Caroline Owen - 'Central Park' Objection

Central Park SSD5700-2012 Block 4S and corresponding applications MP MP06_0171 MOD8, Modification to Approved Concept Plan MP 06_0171 MOD 806_0171 MOD8 & Section 75W Application

Objection: SSD5700-2012 Block 4S, Central Park, Chippendale

Diagram A: Proposed Block 4S in context of other large scale student housing blocks

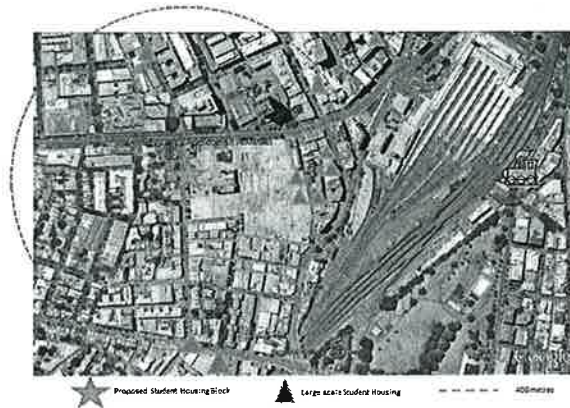
Further, the impact on local amenity as a consequence of students attending local universities needs to be considered. For example, the University of Notre Dame has expanded its operations from 380 students to about 4,000 FTE in the last few years without providing sufficient amenity or having a Master Plan; there has also been a substantive increase in the University of Technology's student population. Both universities are reliant on what little amenity there is in the area. This differs from the University of Sydney which has extensive open space on their grounds.
